CITY OF SAVANNAH

HISTORIC PRESERVATION COMMISSION

REQUEST FOR CERTIFICATE OF APPROPRIATENESS

Address: 306 East 34th Street

FRONT ELEVATION - MAIN HOUSE
SCALE: 1/4" = 1'-0"

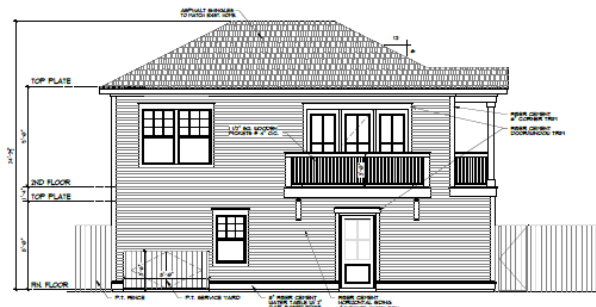
The standard is not met. According to the drawings, the main ridge height of the proposed carriage house will be 24'-3 ¼" where the height of the principal building is 24'-2 ¾" which is nearly identical in height with the ADU being the slightest bit taller. This is not visually compatible and atypical of historic accessory structures which are historically shorter in height. Staff recommends that the applicant confirm the heights are depicted accurately, and if so, should be adjusted to meet the standard.

There are currently no contributing buildings fronting the lane of which to compare, however, in relation to the principal house the standard is not met in the sense that accessory structures are to be subordinate to the principal building and this reads as equal in size, per the drawings as seen below.

The standard is not met. Per the drawings, the proposed ADU would be slightly taller than the primary building.

The standard is not met. The height is noted to be roughly 2" taller than the principal use which will visually make it look either slightly taller or equal in height, neither of which meets the standard of being accessory to the principal building.

The ADU is 24'3 ½" and the principal building is 24'2 ¾" which means that the height of the ADU slightly exceeds the height of the principal building.

- 1. Confirm the full height the height of the principal building to show that the ADU is less than the height of the principal building to meet the ordinance.**
- 2. Revise the width and scale to ensure that the ADU is subordinate to the principal building.**
- 3. Confirm that the office room is not a bedroom by updating the drawings to omit the Murphy bed and the potential closet space.**
